SP2023-006: Site Plan for Stream

PROJECT NUMBER: SP2023-006
PROJECT NAME: Amended Site Plan for Stream
SITE ADDRESS/LOCATIONS: 1351 CORPORATE CROSSING

CASE CAPTION: Discuss and consider a request by Dylan Adame of Kimley-Horn and Associates, Inc. on behalf of Grayson Hughes of Stream 1515 Corporate Crossing, LP for the approval of an Amended Site Plan for a warehouse/distribution center facility on a 43.237-acre parcel of land identified as Lot 1, Block A, Stream 549 Addition, City of Rockwall, Rockwall County, Texas, zoned Light Industrial (LI) District, situated within the FM-549 Overlay (FM-549 OV) District, located east of the intersection of Corporate Crossing [FM-549] and Capital Boulevard, and take any action necessary.

TREESCPE PLAN & DETAIL
 SHEET NUMBER
T-100

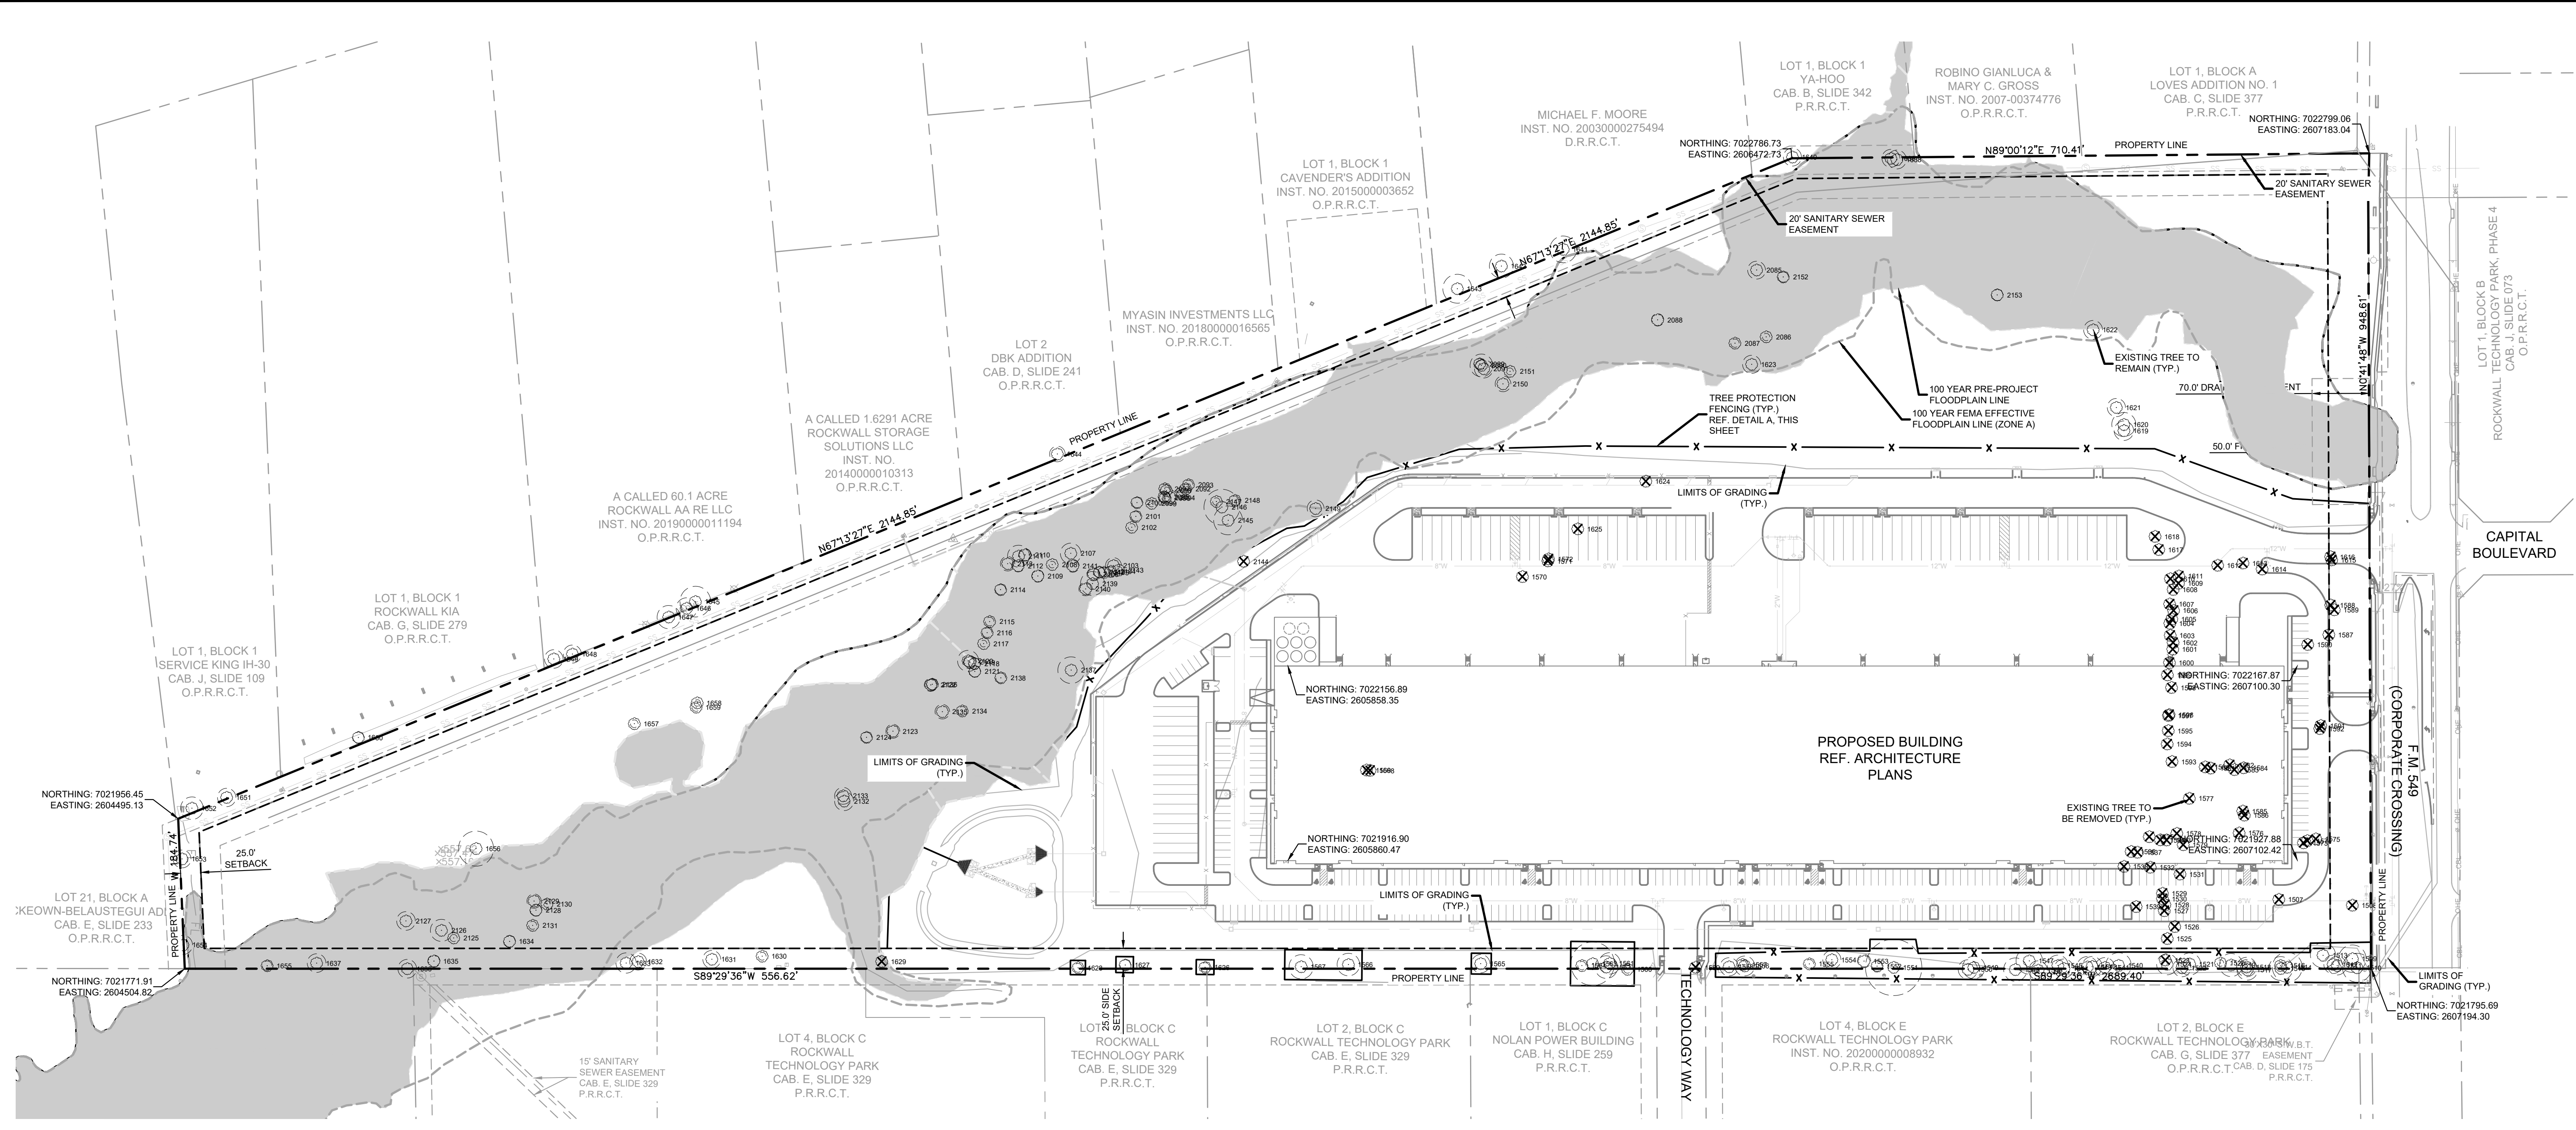
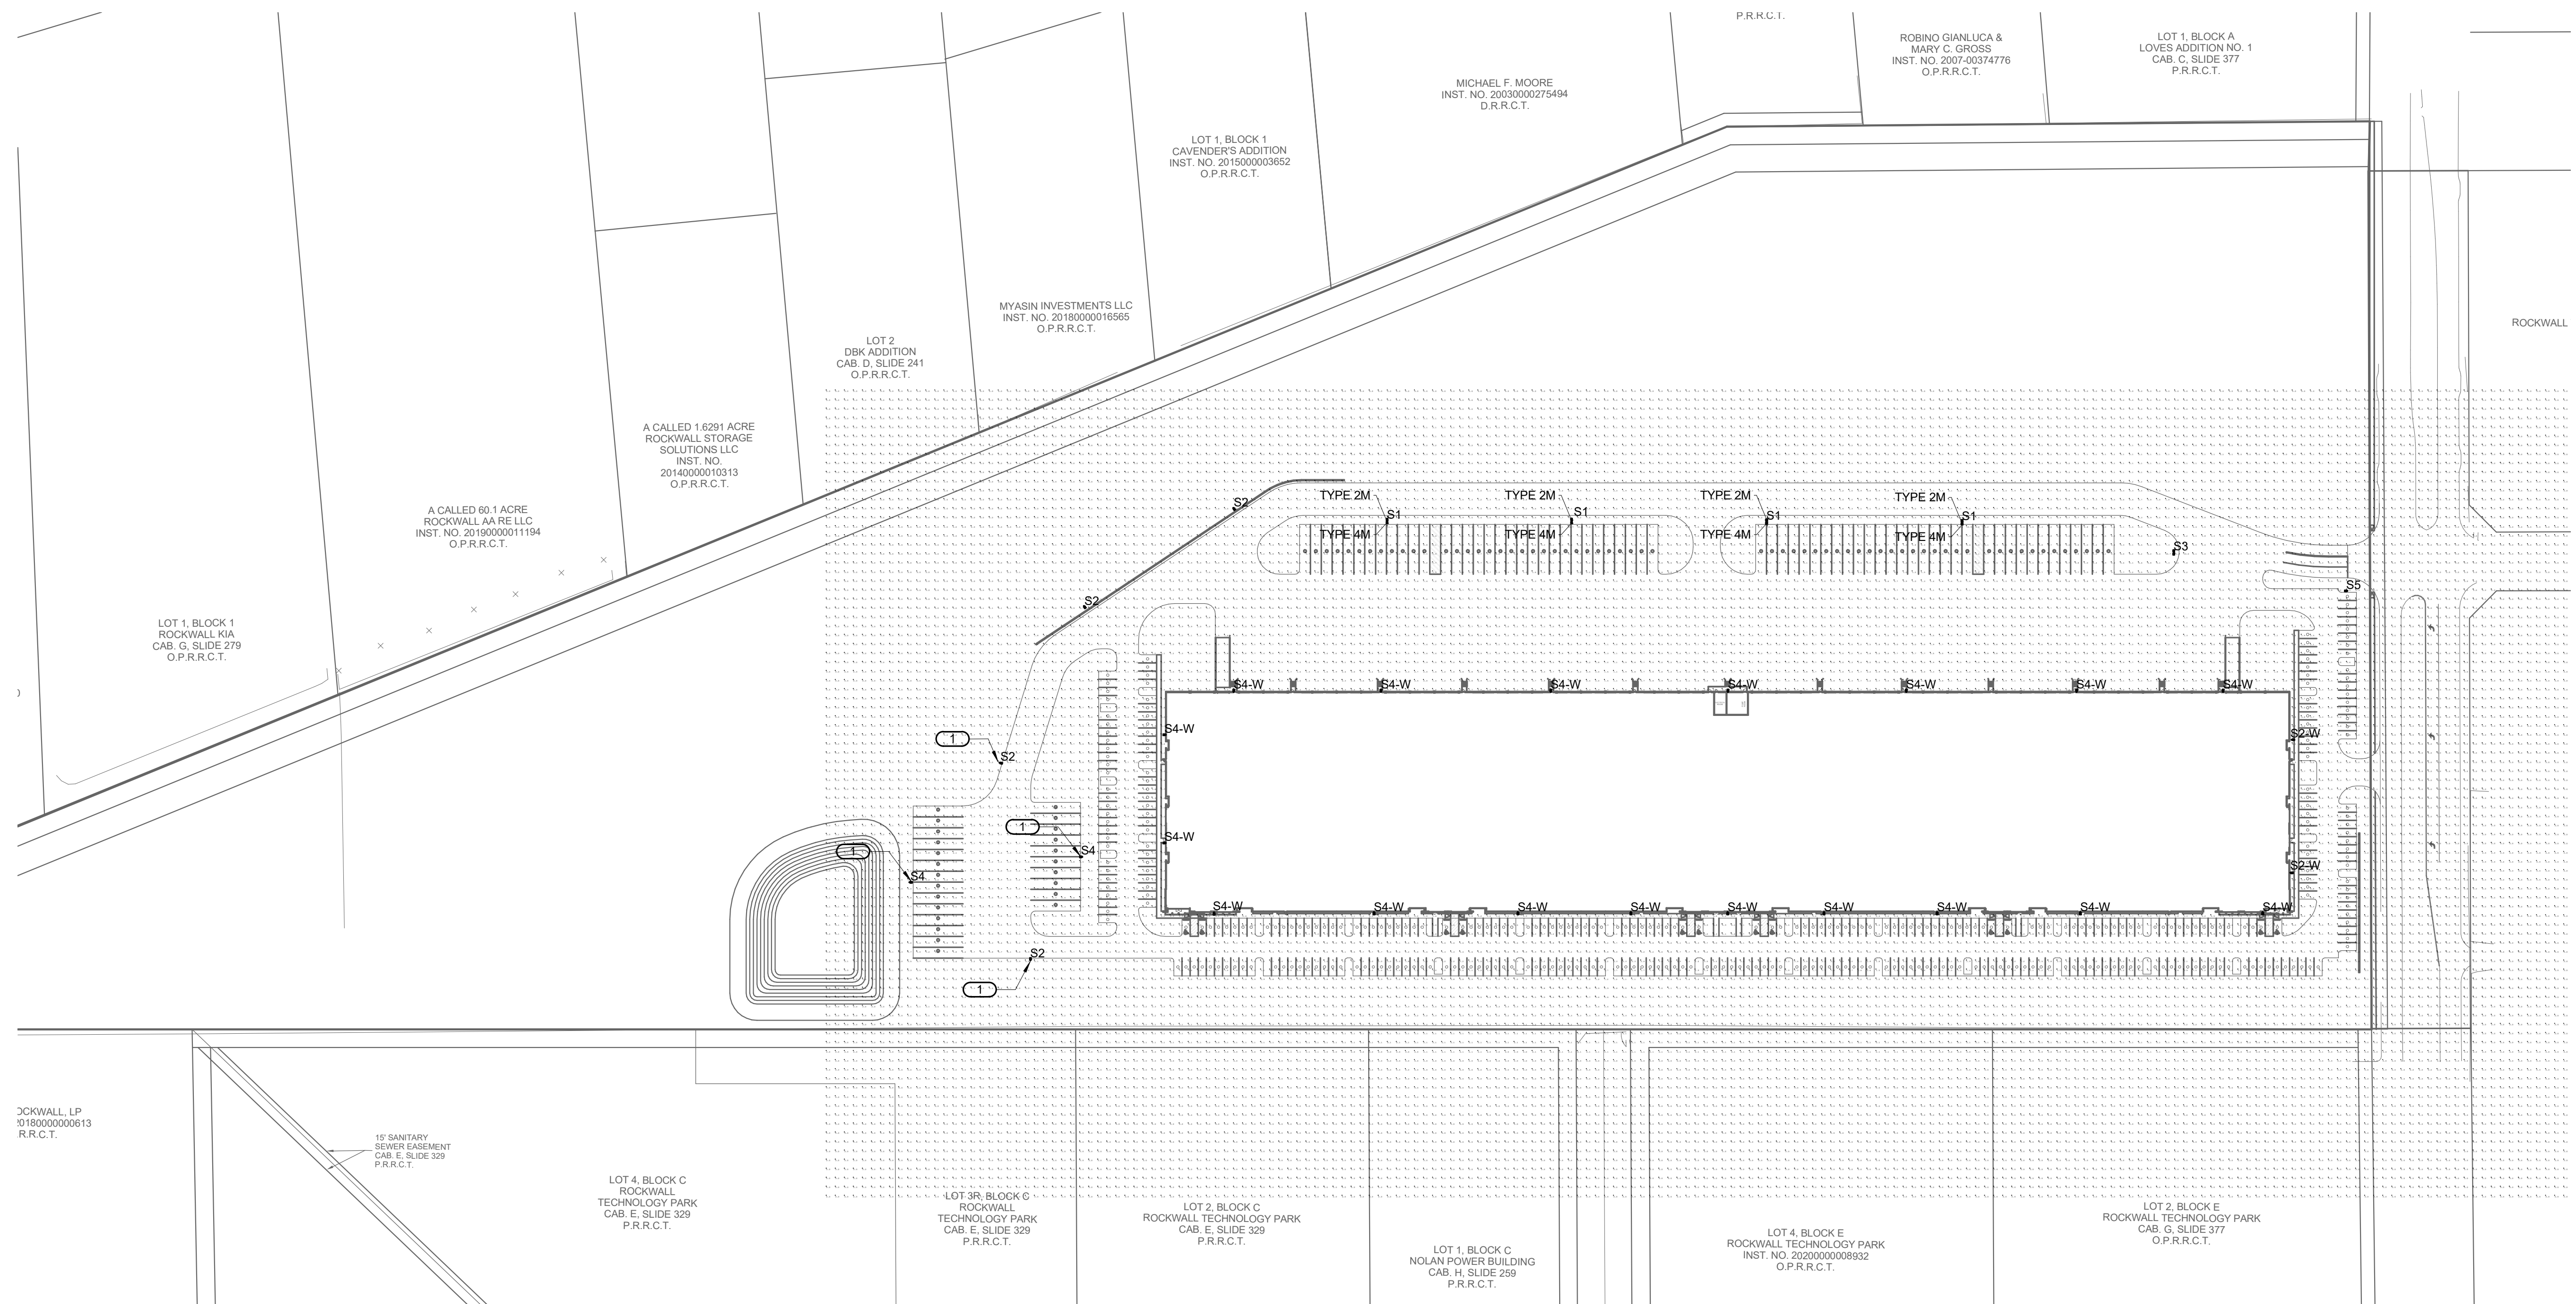
(1) Accent trees do not count towards the mitigation balance. This means that 604-inches are being planted and not 900-inches. That being said, the mitigation balance is still covered. (Subsection 03.01. B, of Article 09)

ELECTRICAL LIGHTING PHOTOMETRIC PLAN

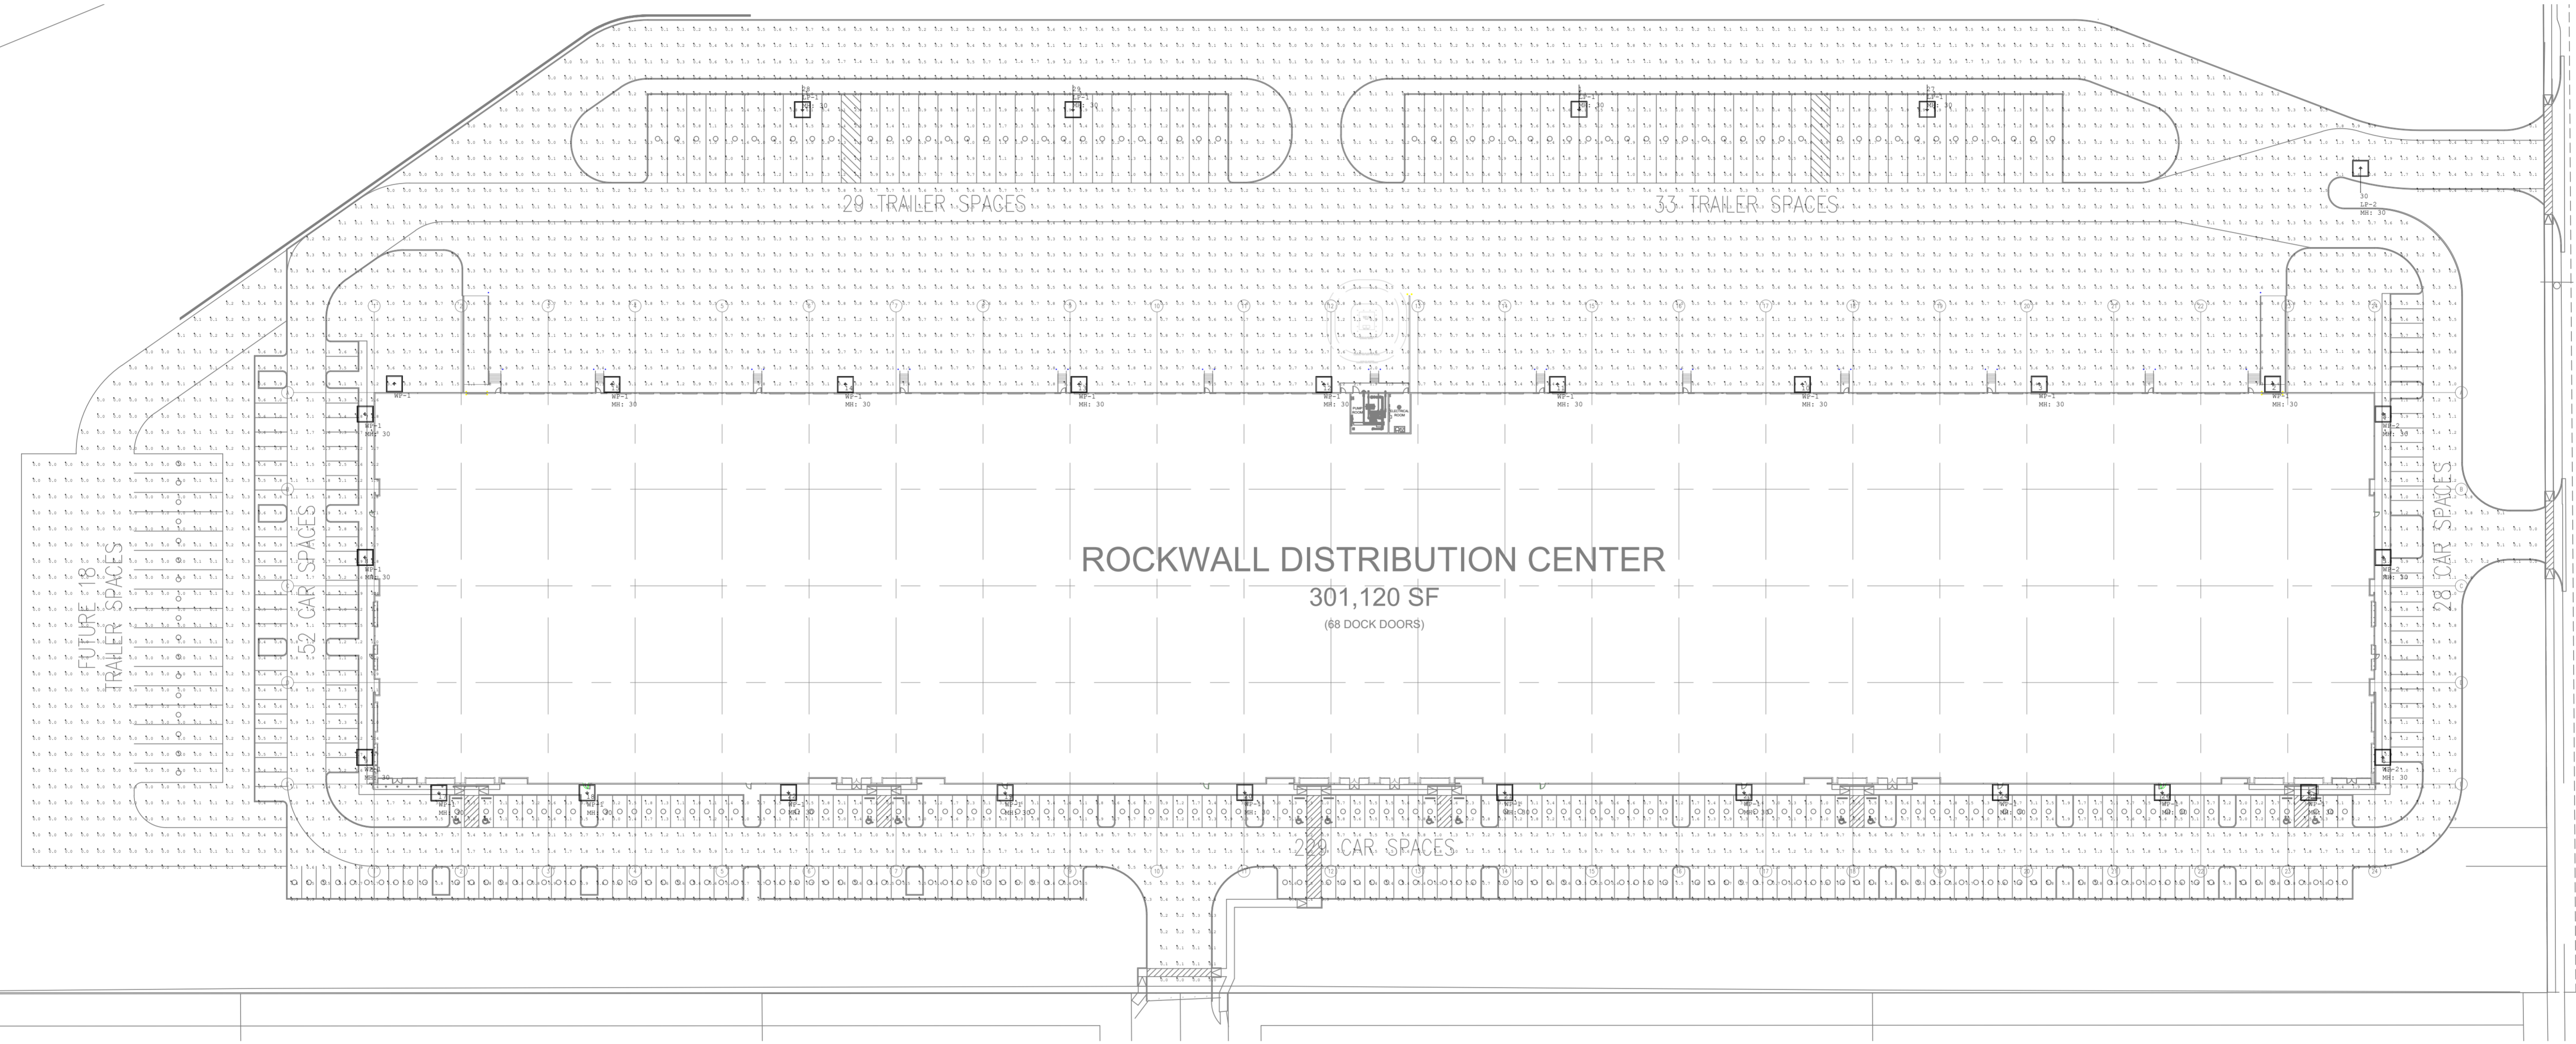
- (1) Provide the site data information required in Section 2.1 of this checklist. (See Section 2.1 of this Checklist)
- (2) All lighting must be mounted at 20-feet or less per the General Overlay District Standards. (Subsection 03.03. D, of Article 07)
- (3) Please provide cutsheets for all of the proposed light fixtures. (Subsection 03.03. A, of Article 07)

NOTE:
Per Rockwall UDC, no wallpacks or site lighting shall be mounted above 20'-0", typical
